Well Name: JRU APACHE FEDERAL COM	Well Location: T22S / R30E / SEC 13 / NESE / 32.391927 / -103.828228	County or Parish/State: EDDY / NM
Well Number: 111H	Type of Well: OIL WELL	Allottee or Tribe Name:
Lease Number: NMNM89051	Unit or CA Name:	Unit or CA Number:
US Well Number:	Operator: XTO PERMIAN OPERATING LLC

Type of Submission: Notice of Intent Type of Action: APD Change

Procedure Description: JRU APACHE FEDERAL COM 111H APD ID# 10400085713 SUNDRY LANGUAGE XTO Permian Operating, LLC. respectfully requests approval to make the following changes to the approved APD. Changes to include SHL, KOP, FTP, LTP, BHL, casing design, cement program, mud circulation system, proposed total depth and pool. FROM: TO: SHL: 2575' FSL & 817' FEL OF SECTION 13-T22S-R30E 2576' FSL & 867' FEL OF SECTION 13-T22S-R30E KOP: 2575' FSL & 817' FEL OF SECTION 13-T22S-R30E 544' FNL & 330' FEL OF SECTION 13-T22S-R30E FTP: 330' FNL & 330' FEL OF SECTION 13-T22S-R30E 544' FNL & 330' FEL OF SECTION 13-T22S-R30E LTP: 330' FNL & 100' FWL OF SECTION 14-T22S-R30E 544' FNL & 100' FWL OF SECTION 14-T22S-R30E BHL: 330' FNL & 50' FWL OF SECTION 14-T22S-R30E 544' FNL & 50' FWL OF SECTION 14-T22S-R30E The proposed tota

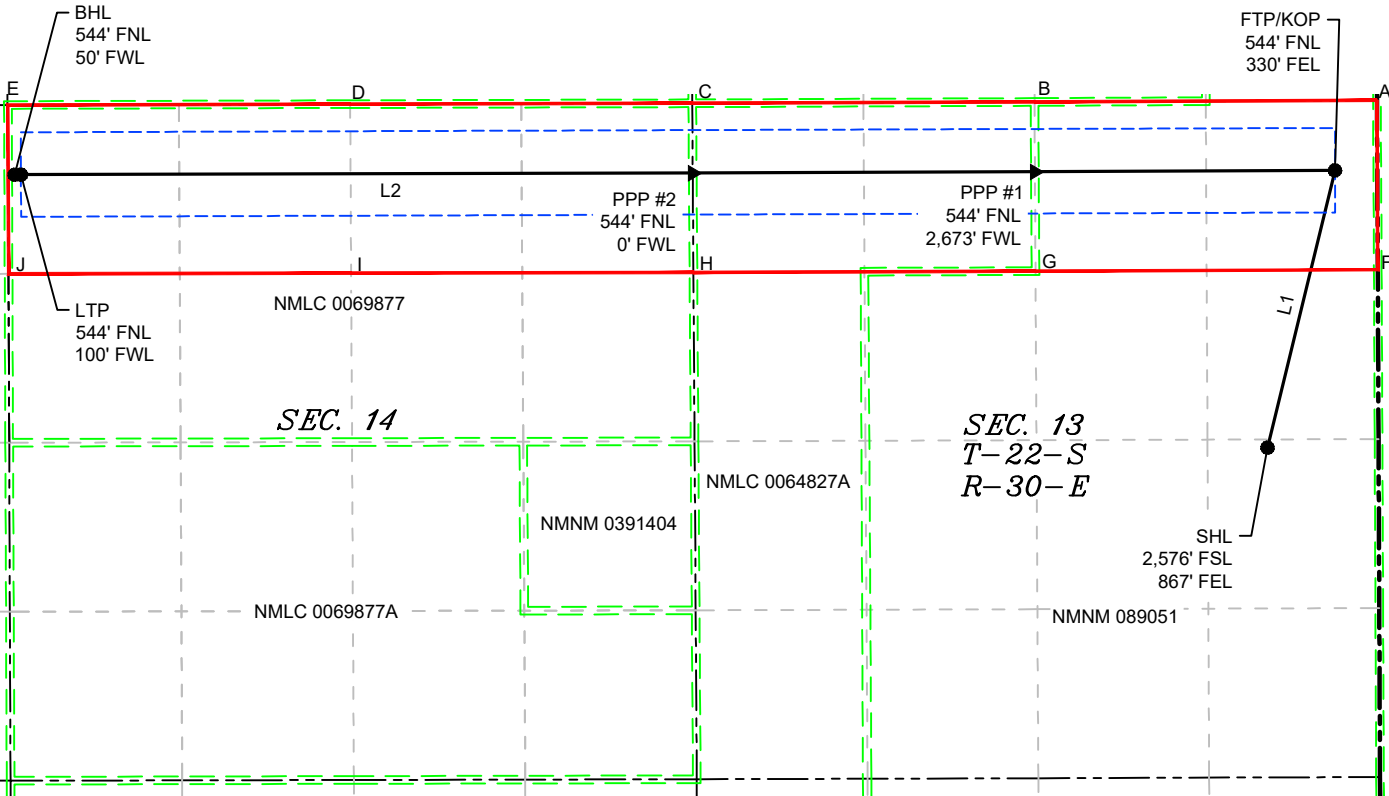
BHL: 330' FNL & 50' FWL OF SECTION 14-T22S-R30E 544' FNL & 50' FWL OF SECTION 14-T22S-R30E

The proposed total depth is changing from 22136 MD/11000 TVD to 21523.1 MD/11082 TVD

The pool is changing from Los Medanos; Wolfcamp, South to Los Medanos; Wolfcamp, North (Gas) and Los Medanos; Wolfcamp (Gas).

Individual C102s for each pool highlighting the corresponding dedicated acreage are attached.

[Figure F] 4 String – 2nd Intermediate casing engineered weak point

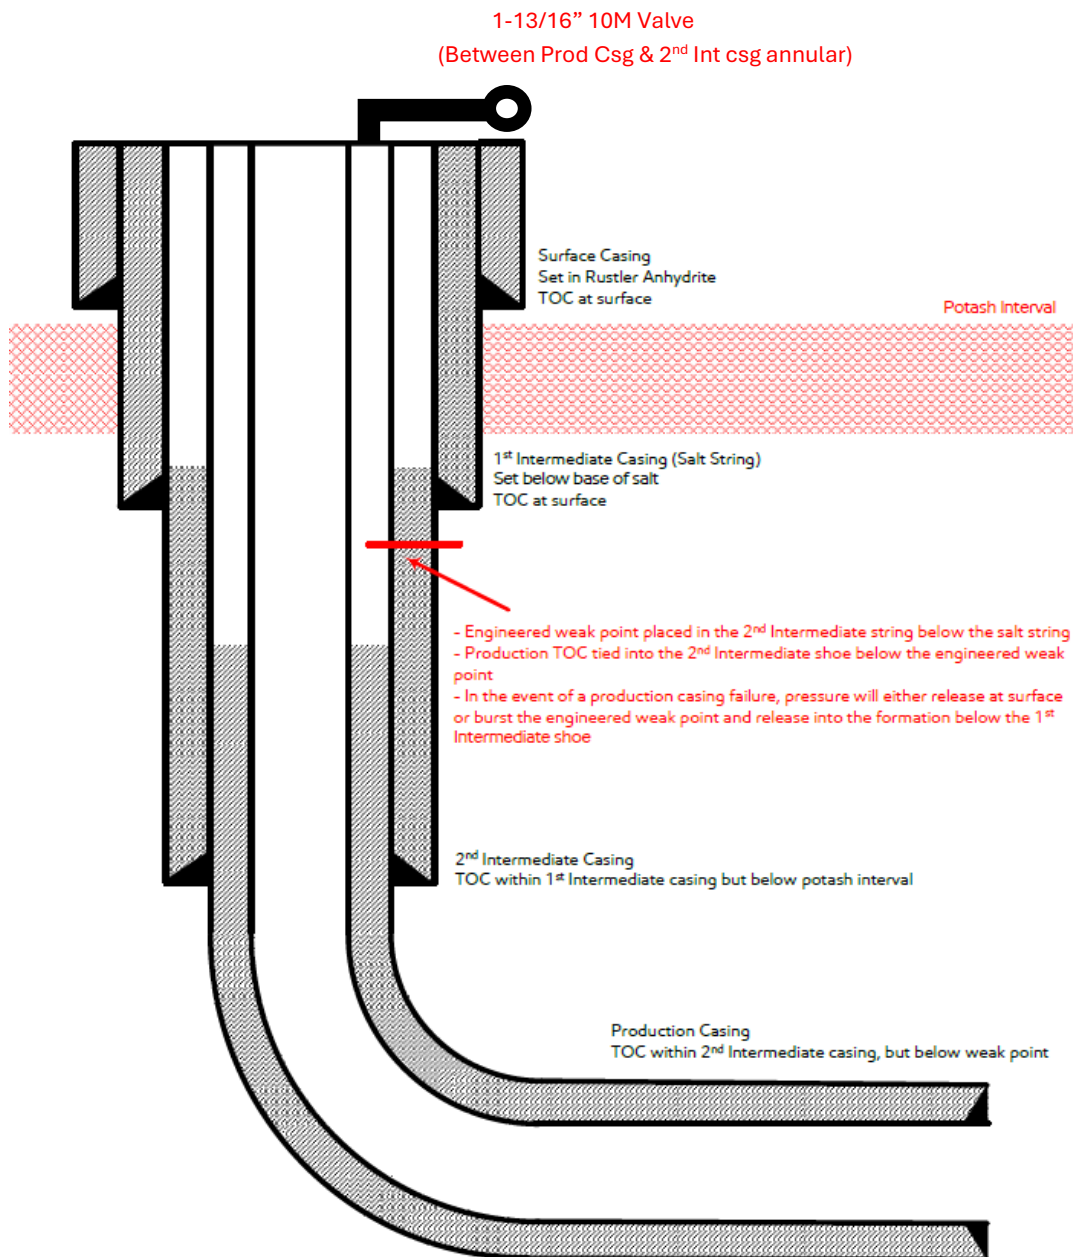
- 1) Alignment with KPLA requirements per schematic below, with engineering weak point casing design and utilizing new casing that meets API standards.
- 2) Contingency plans in place to divert fluids away from salt interval in event of production casing failure.
- 3) Intermediate 2 casing will consist of a primary cement job with TOC at the top of the Brushy Canyon formation within the Delaware Mountain Group.
 - a. Bradenhead squeeze to be completed after primary cement job to tie back TOC to intermediate 1 "Salt string" & below Marker Bed 126 "Potash Interval".
- 4) Production cement to be tied back no less than 500' inside previous casing shoe (intermediate 2 casing) and below the engineered weak point.
